COA # 2009-COA-629 (RP)	INDIANAPOLIS HISTORIC PRESERVATION COMMISSION STAFF REPORT	Hearing Date OCT 6, 2010
1010 Dr Martin Luther King Jr Street RANSOM PLACE		Continued from: Sept 1, 2010 August 4, 2010 July 7, 2010 June 2, 2010 May 5, 2010 April 7, 2010 Center Township Council District: 9 Jackie Nytes
Applicant Feroze and Sons LLC, Mo Hanif mailing address: 441 E Ohio Street Indianapolis, IN 46204		
Owner: same		
CASE		
IHPC COA: 2009-COA-629 (RP) <ul style="list-style-type: none"> • Construct new structure, gas pump island and canopy • Site Improvements/landscaping 		
STAFF RECOMMENDATION: Denial

Above: Site Plan from August's Staff Report Below: Proposed Site Plan

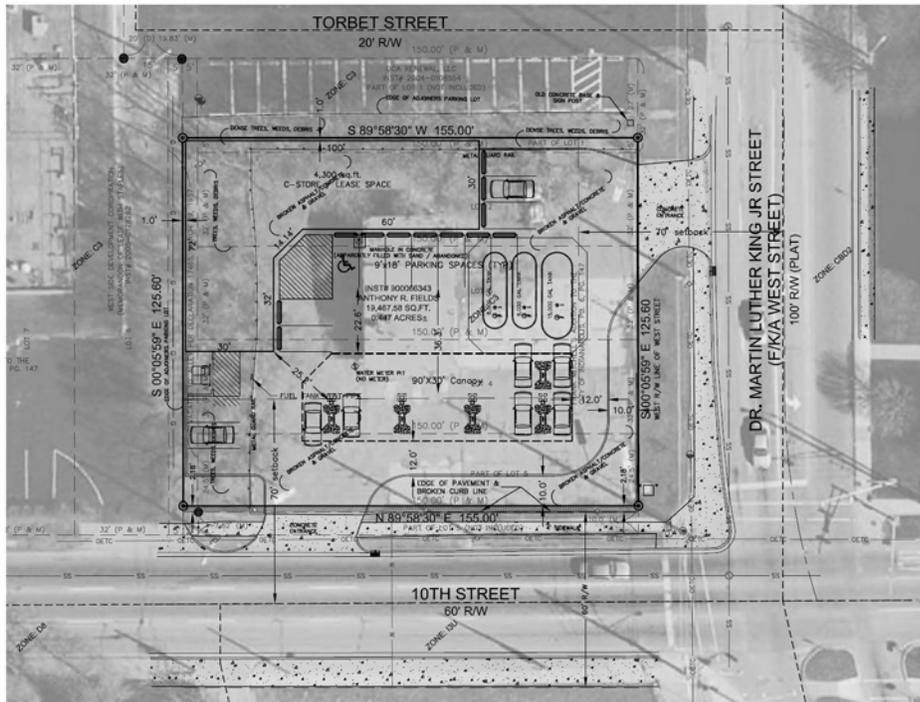
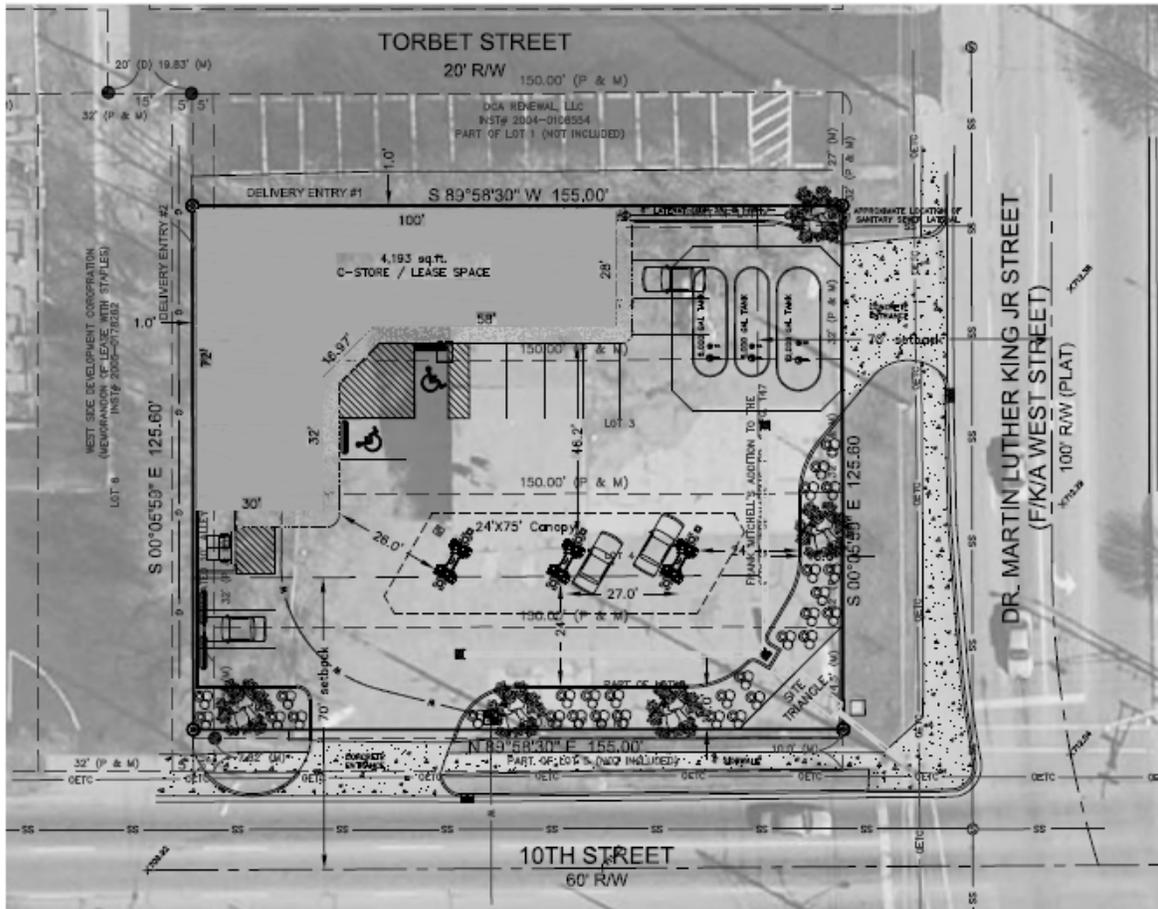
At the last hearing, the issue of maneuverability was raised. Several Commission members commented on “tightness” of the site. The new site plan shows less pumps on the site and generally more room to maneuver, however, the turning radius drawing appears to show some complications with cars potentially in each other paths, particularly at the south entrance and west entrance. It also appears from the new site plan that the amount of space provided to enter and exit the site could be in direct conflict with the flow of the traffic moving on the site.

1. The building appears to be too large for the site causing strain on the usability of the parking spaces
2. The maneuverability on the site appears tight, especially at the pumps and entrances to the site
3. Even though the required number of parking spaces is available (14 needed, 17 provided), the maneuverability around these parking spaces is tight. This is partly due to the fact that the C-3 zoning ordinance allows the parking spaces at the pumps to be included in the calculation and because the building may be too large.
4. The applicant has not further developed the architecture of the building and canopy as requested

The commercial zoning ordinance references the Eighth Edition of the Architectural Graphics Standards. Staff is recommending that the final site plan be consistent with these standards:

Minimum parking lot and parking space dimensions.
The interior access drives, interior access driveways, drives, driveways, entrances, exits, aisles, bays and traffic circulation for parking lots and parking garages shall be designed and constructed at not less than the recommended specifications contained in Architectural Graphic Standards, Eighth Edition, Ramsey/Sleeper, John Wiley and Sons, Inc., New York, New York (a copy of which is on file in the office of the division of planning and is hereby incorporated by reference and made a part hereof).

Above: New Elevations
Below: Old Elevations

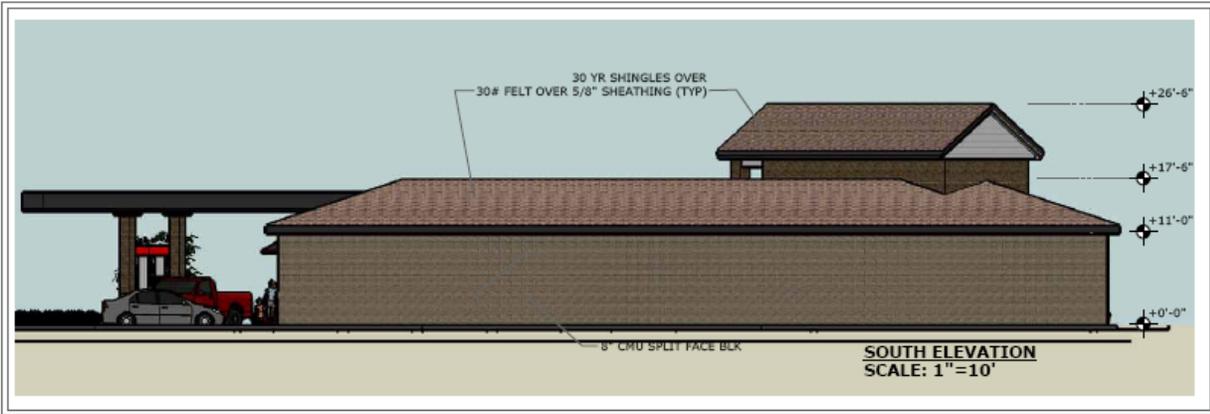
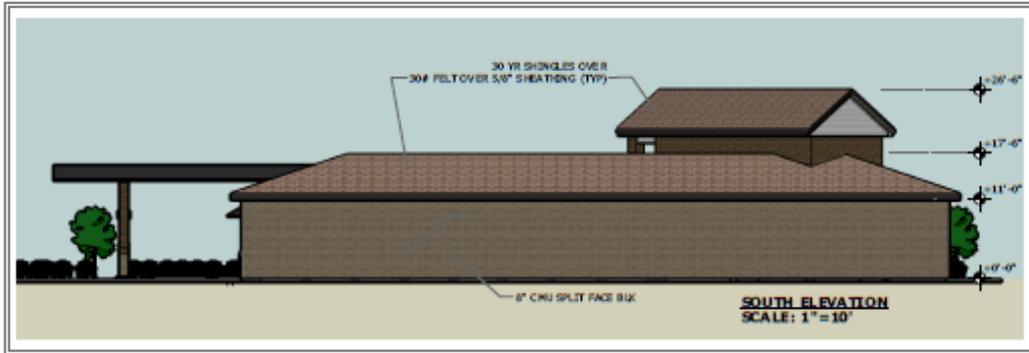
The drawings currently show fiber cement siding in the tower gable, but staff suggested at the last hearing that this be modified to fiber cement panels instead. Since the August hearing, the fiber cement lap siding has remained and fiber cement panels are not shown on the plans. Several comments about the design of the building were also raised by the Commission. It was mentioned that the north and west sides of the building contained no windows and that windows or some type of articulation would improve these elevations. No windows or articulation have been added.
